What we heard report

Stage 1 public consultation: Draft Billabong Creek Floodplain Management Plan

March 2025

Figure 2: Key floodways within Two-Mile Creek that were not activated during the 2012 flood event

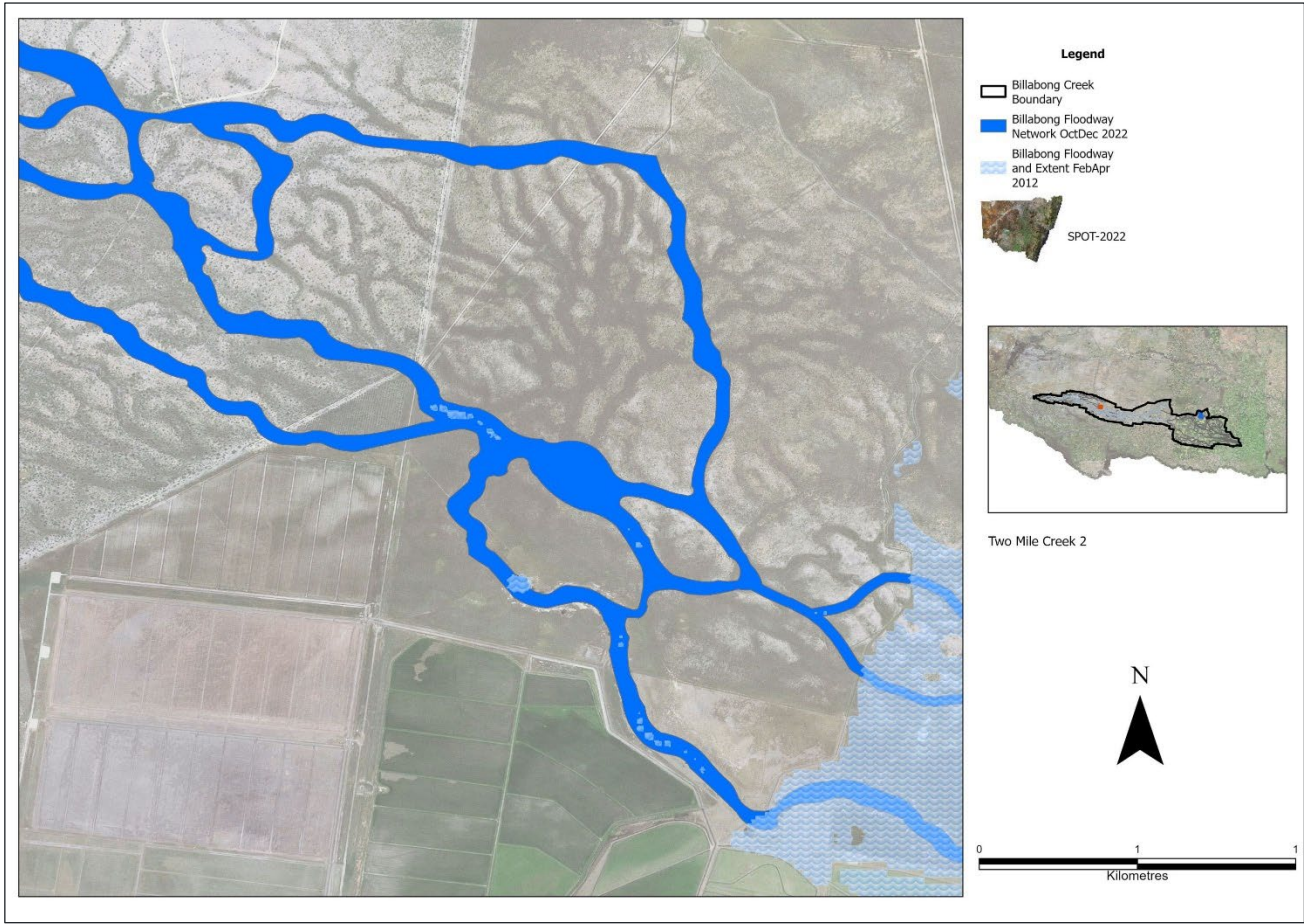
Feedback	Departmental response
Why are you using the 2022 flood event as the large flood design event? The 2022 flood event would be a 1 in 100-year flood. The 2012 flood would be more appropriate as a typical large flood for this area of the floodplain and is more likely to occur.	The department has undertaken a review of historical flood events in the Billabong Creek floodplain and has confirmed that the 2022 flood event is the most appropriate for the purposes of delineating the extent of the proposed floodway network, as: • it meets the majority of the criteria for a large design flood event • the 2012 flood event only meets one of the criteria for a large design flood event • spatial analysis of the 2012 flood event shows that the floodway network was underrepresented in key areas of the floodplain, compared to the 2022 flood event • analysis of historical flood events showed that the 2022 flood event was more similar

This analysis showed that the 2012 flood event underrepresents key floodways in a number of locations in the lower Billabong Creek area of the floodplain. Examples are shown in Figure 2 and Figure 3 for Two Mile Creek and Carroonboon Creek respectively. The darker blue area in the figure indicates the proposed floodways using the 2022 flood event while the light blue shows the inundation extent using the 2012 flood event. The difference demonstrates that the 2012 flood event does not reach the threshold for inclusion as floodways (depth and velocity product) but the thresholds were met in the 2022 flood event.

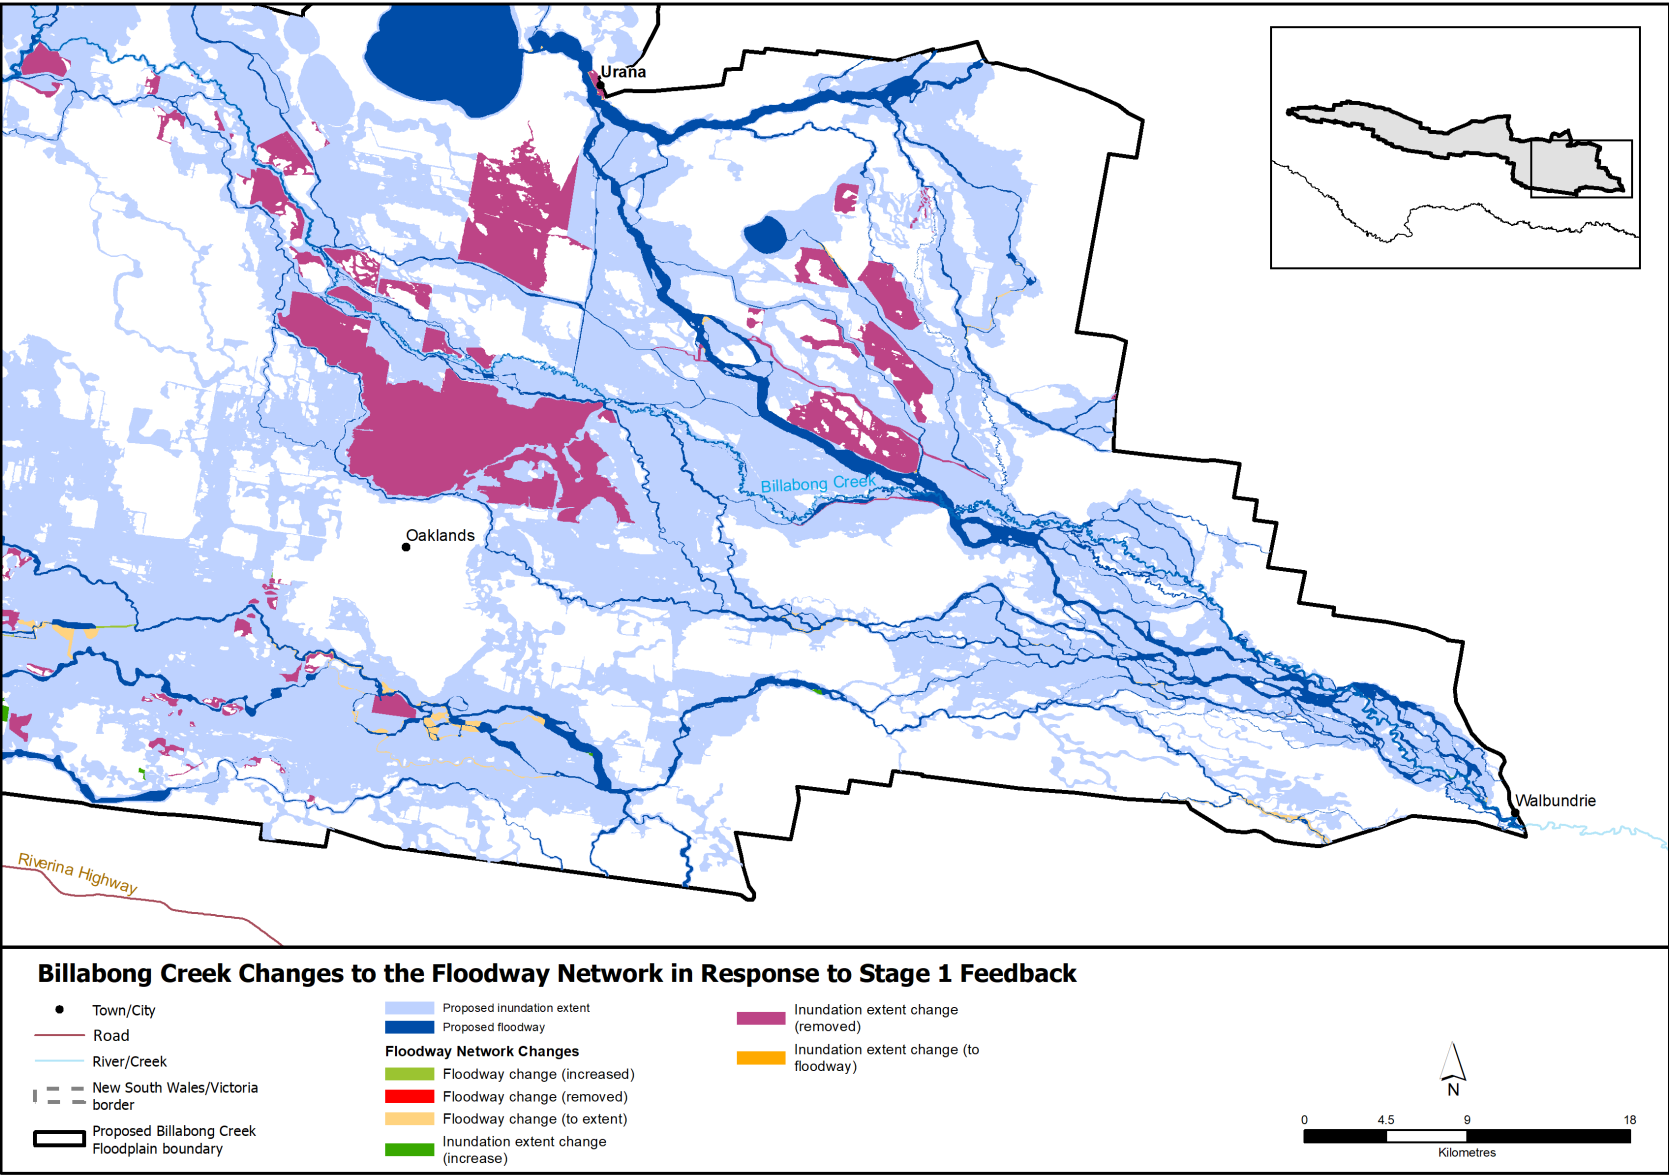
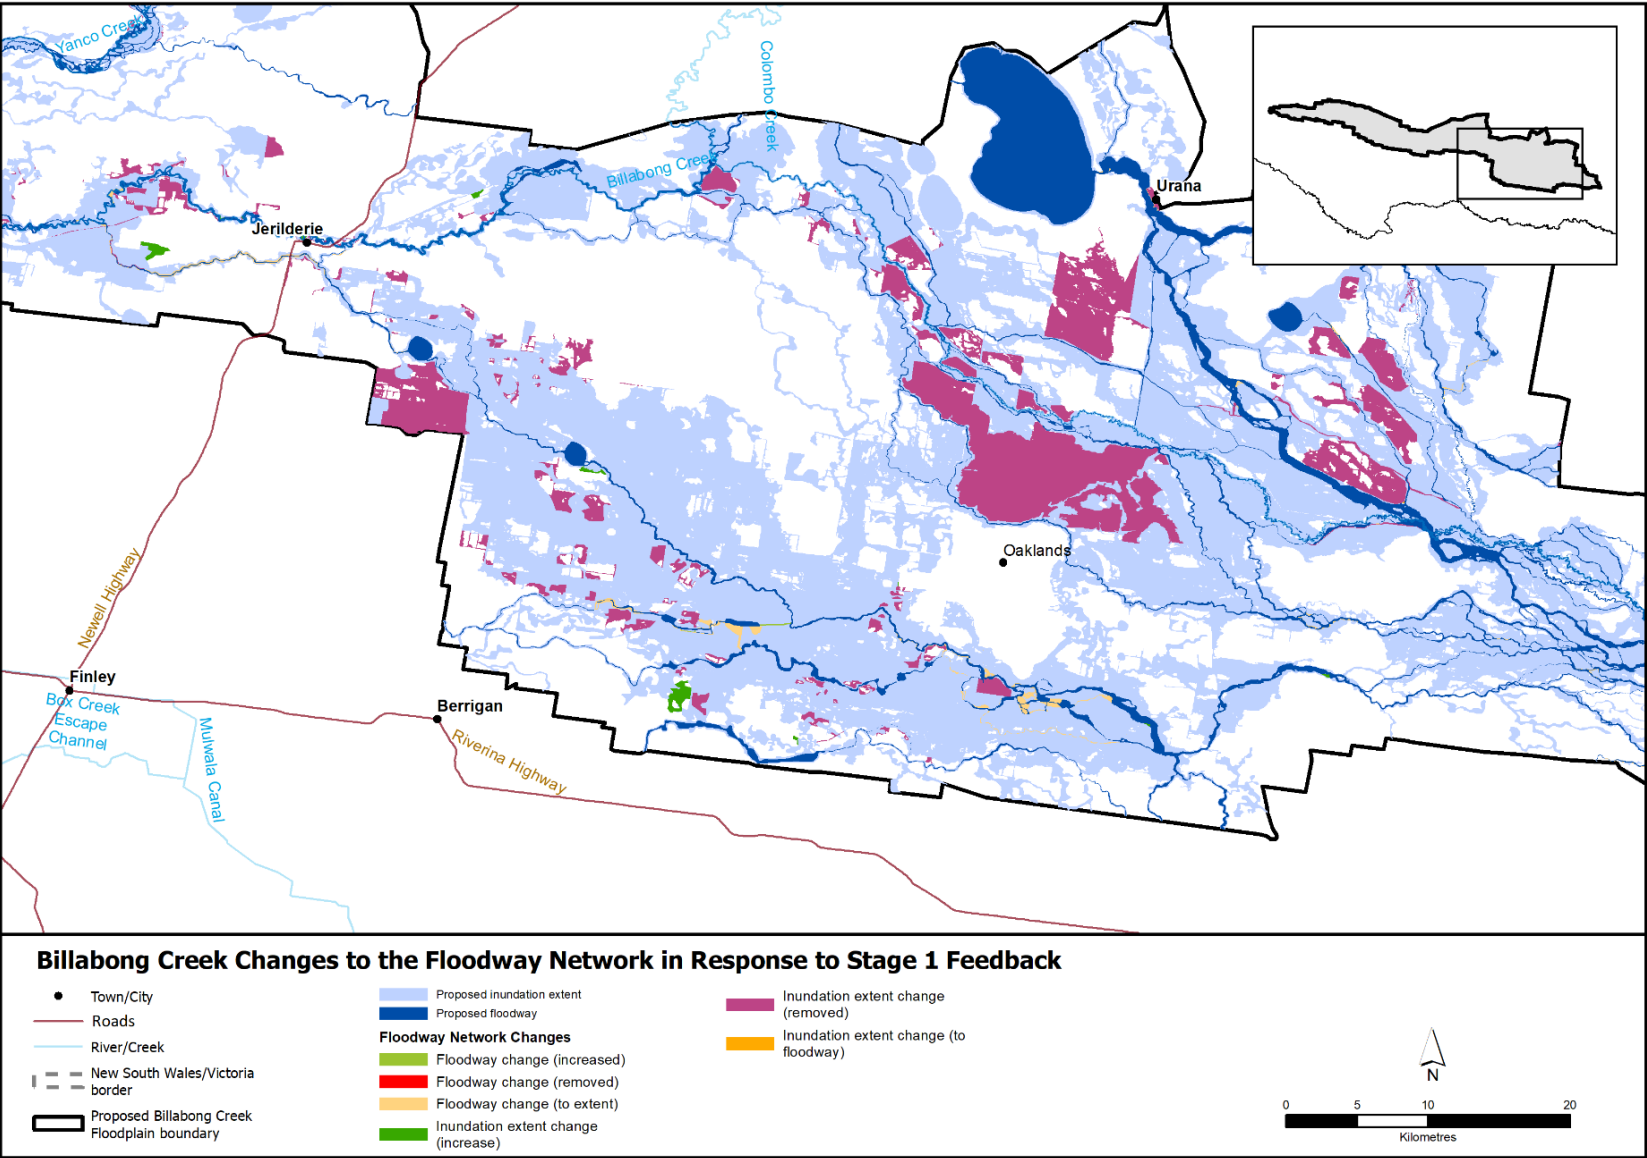
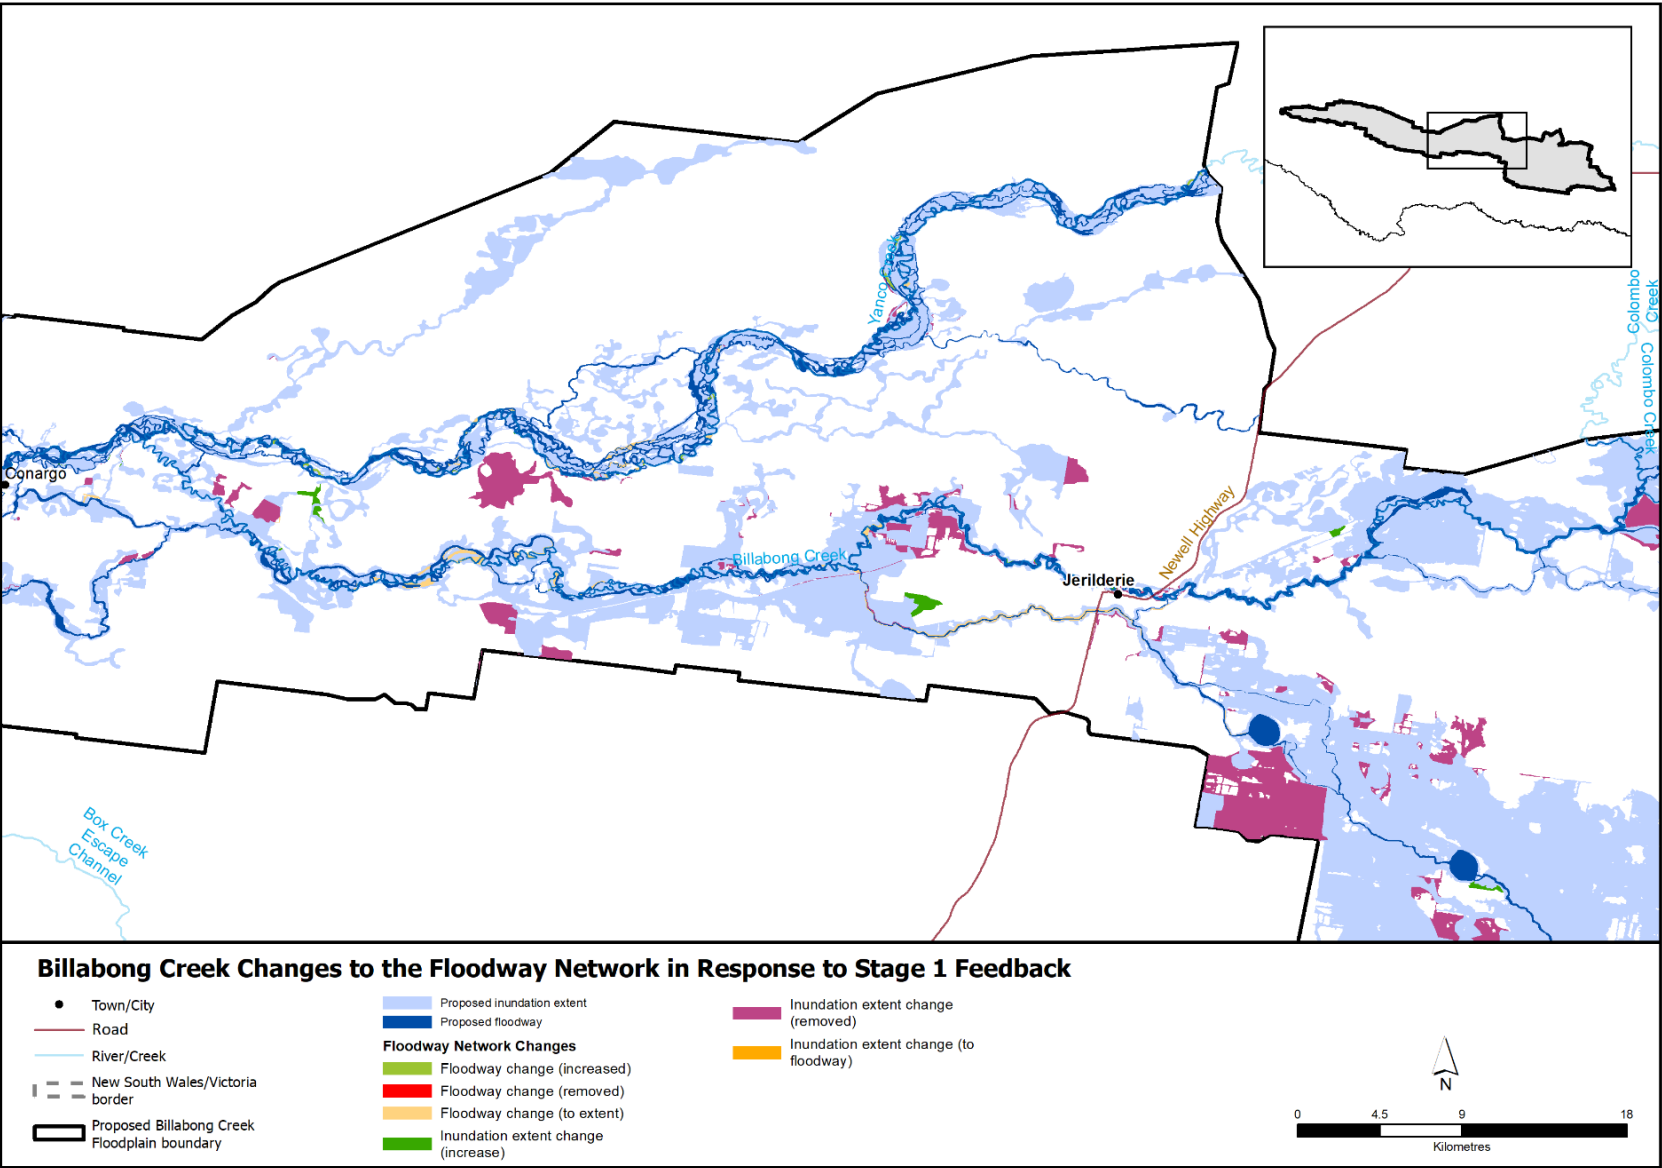
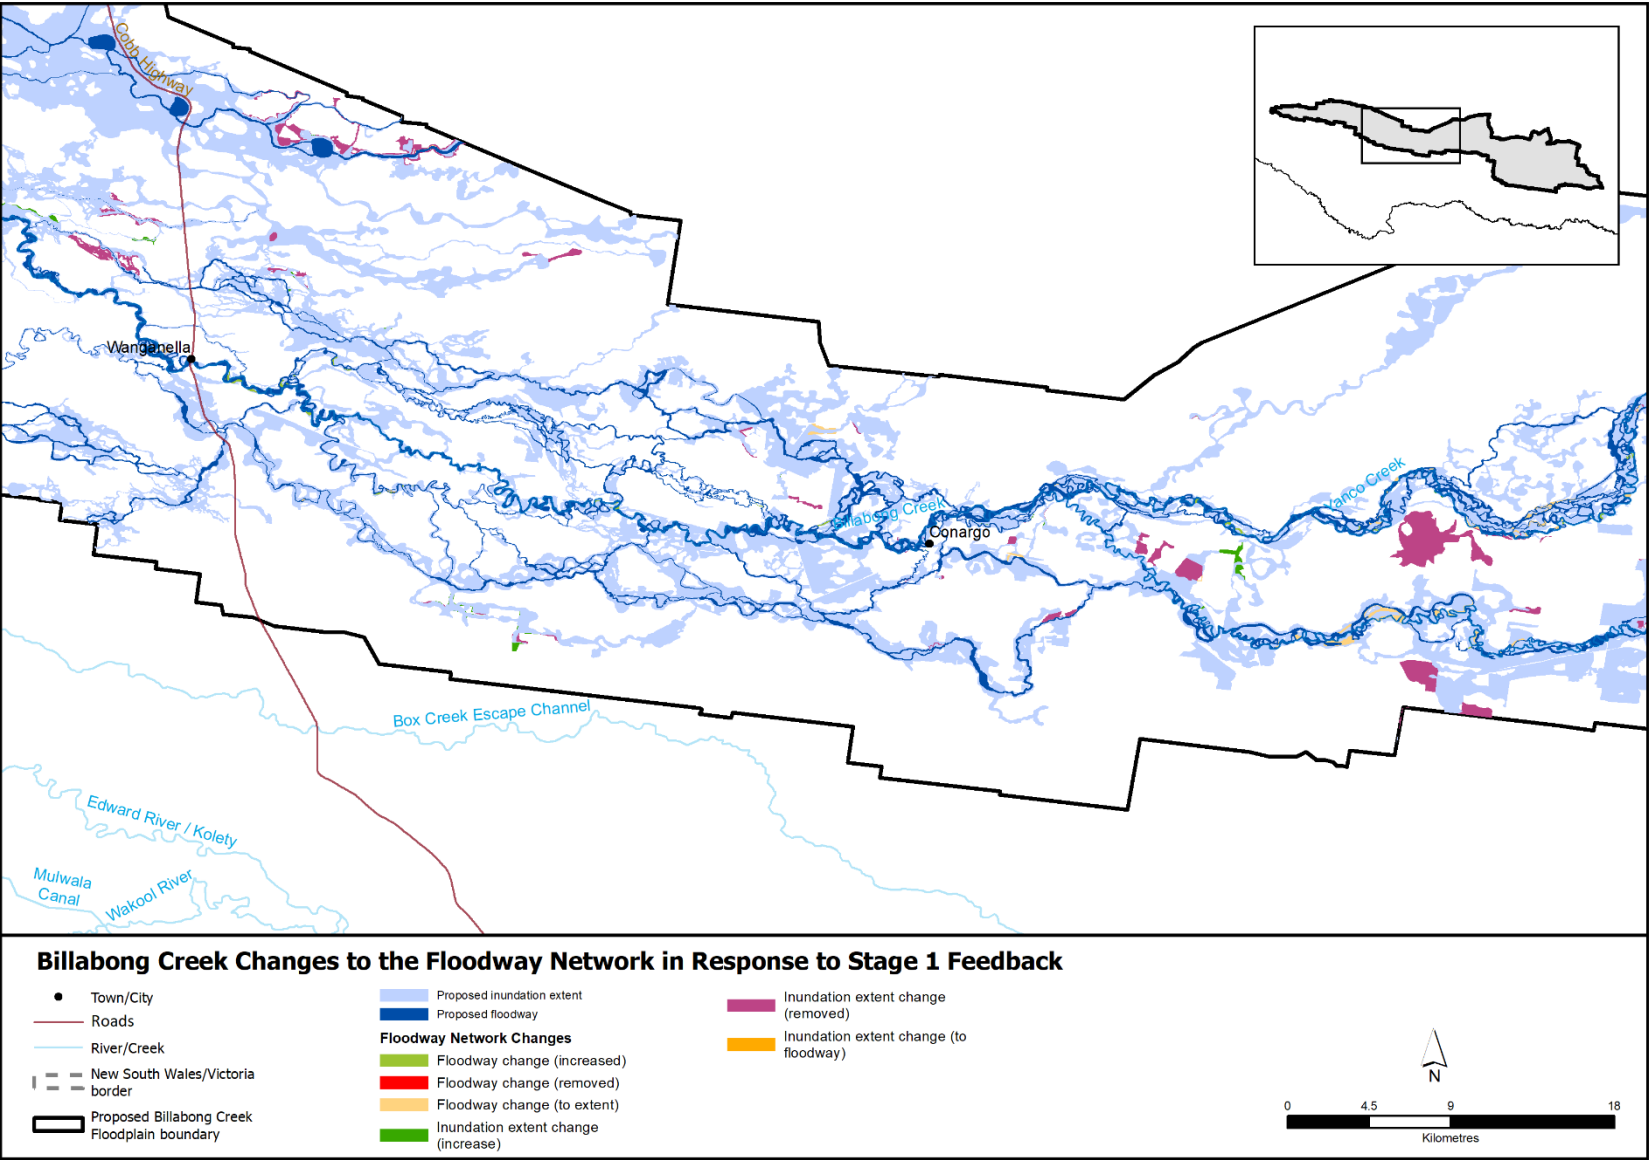
The proposed floodway network is incorrect in many areas as it covers areas that didn't flood in 2022. The 2012 flood should be used instead for modelling and mapping the floodway network.	The proposed floodways and inundation extent at some locations may differ from that experienced during flood events as they include a process for the consideration of unapproved flood works, as shown in Figure 8 in the <u>Report to assist Stage 1 public consultation</u>. In many instances, unapproved flood works will not be considered in the development of the floodway network. This results in some areas being shown as inundated due to the presence of an unapproved flood work preventing floodwater from moving into the area. The feedback received has resulted in multiple refinements being made to the proposed floodway network. These refinements are shown on Figures 5 to 10 in Appendix 3. Where proposed refinements related to unapproved flood works, no change was made.

Floodway does not match with river network showing on satellite image.	In response to this feedback, the department has reviewed the floodway across the proposed floodplain area against satellite imagery and realigned where needed. These refinements are shown on Figures 5 to 10 in Appendix 3.
The floodway looks accurate on the mapping.	Noted.

A summary of the feedback received is provided in Table 4. In response, the department has refined the proposed floodway network in multiple locations. These refinements are shown in Appendix 3. Where proposed refinements related to unapproved flood works, no change was made. An updated interactive spatial map will be published as part of Stage 2 public consultation of the draft FMP.
